FOUNTAIN WIND PROJECT

FINAL ENVIRONMENTAL IMPACT REPORT – VOLUME 2

Use Permit No. UP 16-007
State Clearinghouse No. 2019012029

Prepared by:
Environmental Science Associates

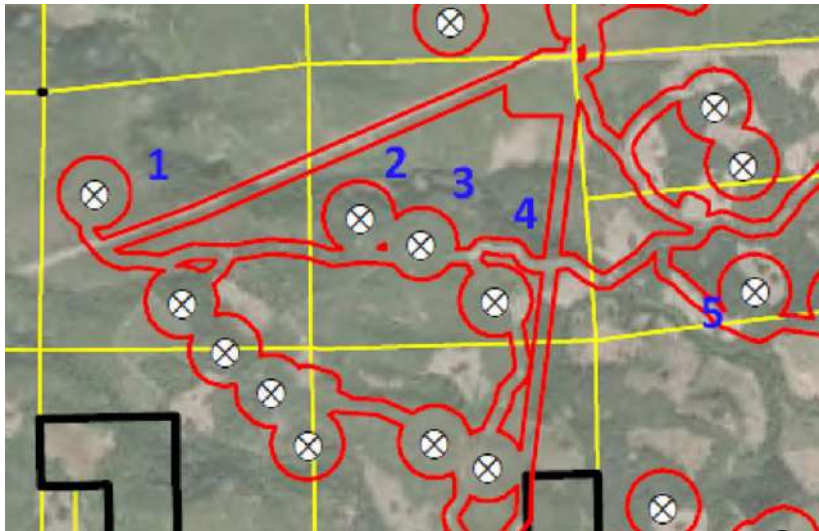
Not True - Five massive turbines will be located along this creek location (see image).

Figure 7. Locations of raptor nests within two miles of Hatchet Ridge.

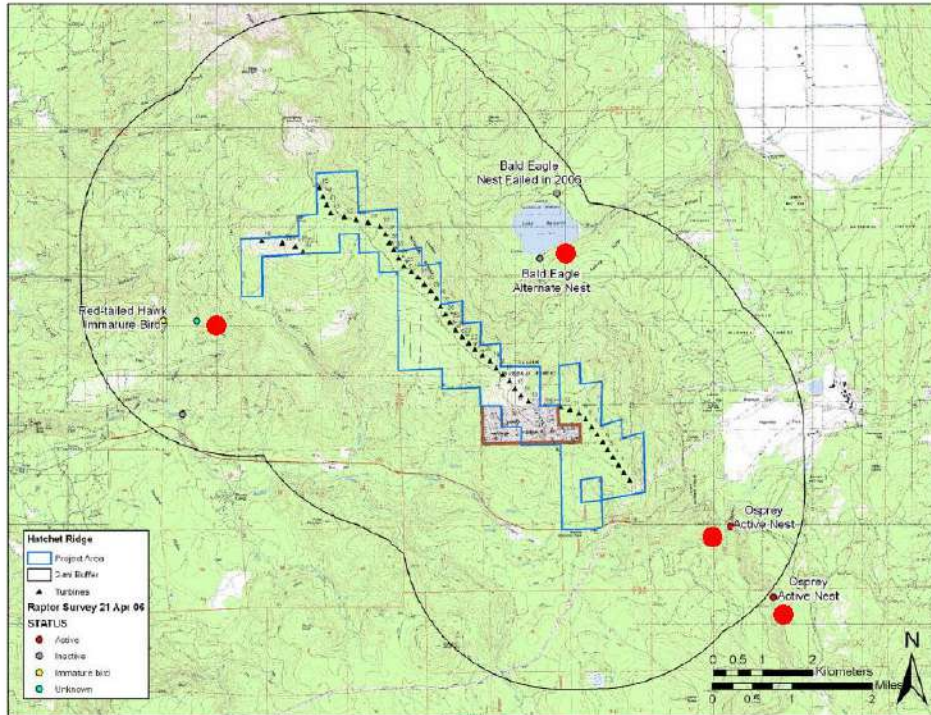
What has happened to these nesting territories since 2010 after 44 Hatchet ridge turbines became operational ???

Figure 3.4-1
Natural Vegetation Communities Found within the Project Site

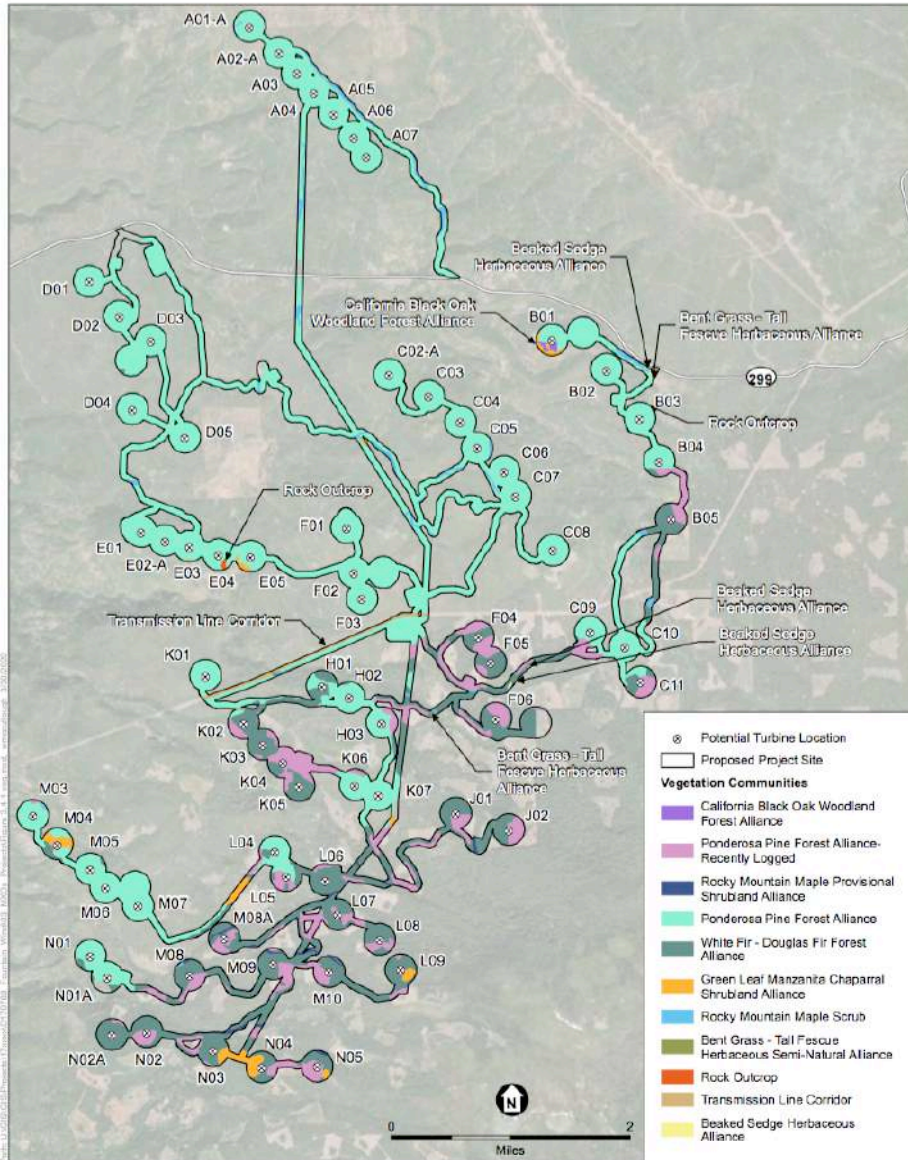
Figure 3.4-1, Natural Vegetation Communities Found within the Project Site presented on page 3.4-5 of the DEIR, and reproduced in Attachment 1 of this letter, only shows vegetation communities proximate to turbines and roads. It is ludicrous to assume that project impacts are limited to the *immediate* vicinity of the project infrastructure. The DEIR's Project Overview (ES.2.1.) states: "The Fountain Wind Project is a renewable wind energy generation development proposed on approximately 4,464 acres in unincorporated Shasta County (Project Site)," whereas page 1 of the Executive Summary of Appendix C, Biological Resources, states: "The proposed Project encompasses approximately 32,600 acres (50.9 square miles) of private land in central Shasta County." By confining the analysis to 4,464 acres rather than 32,600 acres, many of the project impacts are not properly assessed. The removal of habitat to accommodate project infrastructure will impact habitat connectivity over an area greater than 4,464 acres.

Attachment 2

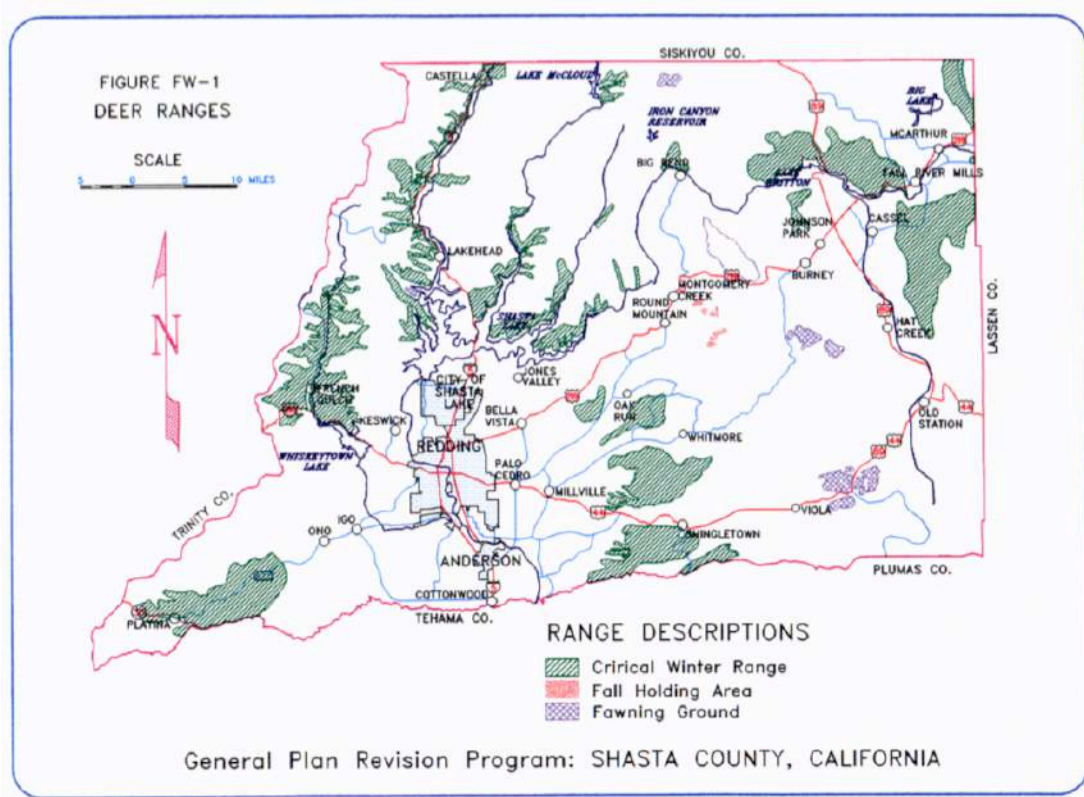
The map in Attachment 2 of this letter, Figure FW-1, *Deer Ranges*, shows much of the project site is a *fall holding area* for deer. If the project were to go forward, the environmental analysis and associated mitigation approach would need to address the requirements discussed in the Joint Hardwood Policy. The DEIR has a number of discussions of deer populations, with discussion of possible interactions with project infrastructure. It needs to also include analysis of proposed project impacts on hardwoods with consideration for deer populations given that the habitat fragmentation impacts extend from the roadways, turbine towers, and other associated infrastructure. Any other hardwood impacts in the 32,600-acre footprint of the project should also be assessed, and mitigation—the DEIR currently has no mitigation for hardwood impacts—should also be calculated based on the project’s full impacts.

The County acknowledges receipt of this copy of Figure FW-1, *Deer Ranges*, from the County's General Plan. The Draft EIR (at pages 3.4-15, 3.4-27, 3.4-67, 3.6-2, 3.6-16) discloses and considers that the Project Site has suitable habitat for deer fawning and that mammals found in mixed conifer forest include deer. In any conflict among the protection of habitat resources and the timber land use classification, General Plan Policy FW-b instructs that the timber land use classification "shall prevail in a manner consistent with State and Federal laws."⁷⁸

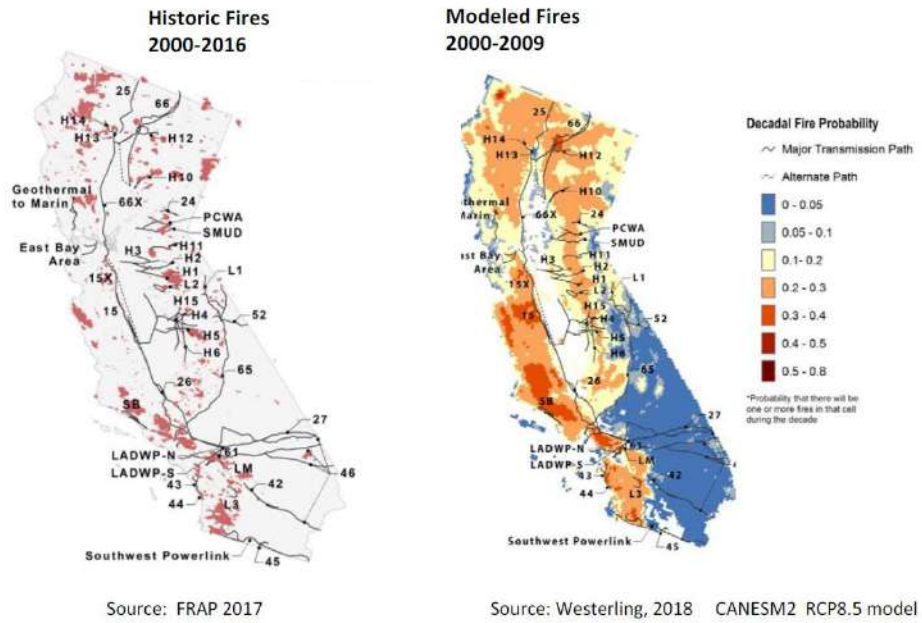
The figure above is included on page 13 of the report titled "Figure 5: The Exposure of California Transmission Paths to Wildfires." Note paths 66 and H12 and their high decadal fire

Figure 8: Projected Change in Future Fire Risk

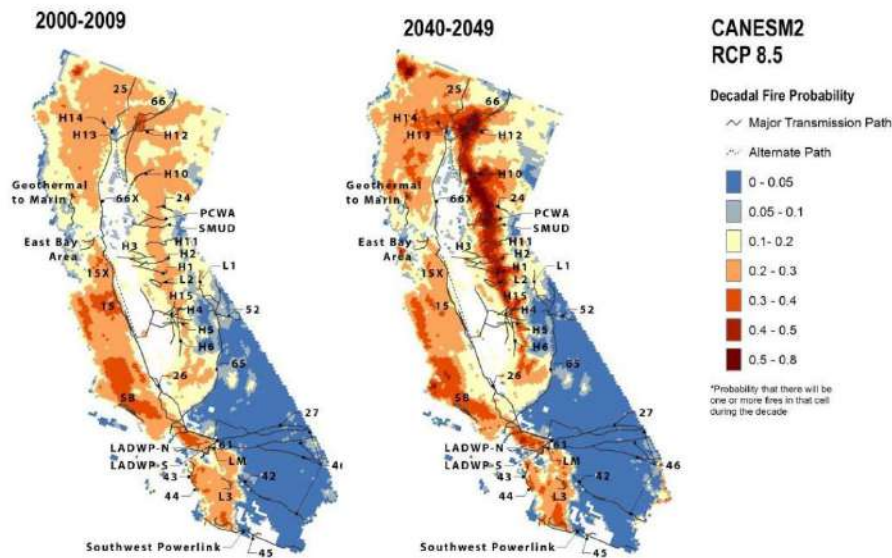
Path 66 is expected to have the largest increase of number of fires from 2040-2049 and largest density. This is also portrayed on the map below from the report.

Possible Slide near E01 (left 2005/right 2016)

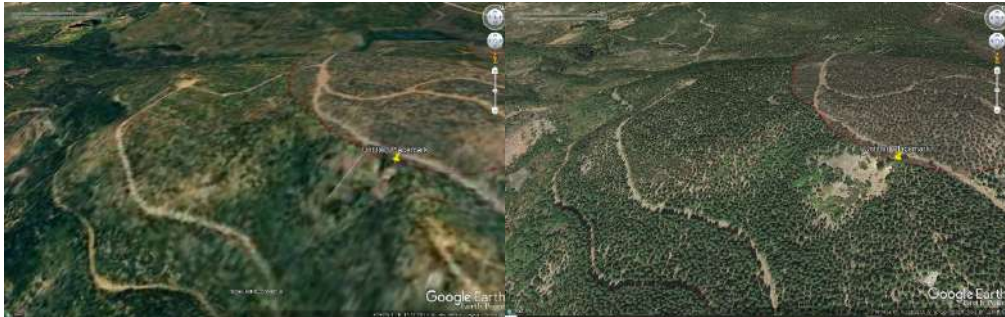
This simply shows that impact 3.9-3 simply is incorrect and possibly intentionally hidden. With the evidence provided they cannot state that the adverse effects directly or indirectly is “less than significant.” Considering the entire area is composed of similar soil and geology. It is insulting particular to those living in the area that know these slides happens and that the report continues to say though no evidence is found a “required-site specific, design-

The comment references a specific location at turbine "I5." However, there is no such turbine location with this attribution as shown in Draft EIR Figure 2-2. Regardless, as stated above, the analysis of landslides hazards in Section 3.9 assumes that landslide hazards are likely present at the site. As discussed on page 3.9-16, all proposed improvements, as required by law, would be subject to applicable provisions of the California Building Code (CBC). As stated on page 3.9-10 of the Draft EIR [**bold text added for emphasis**]:
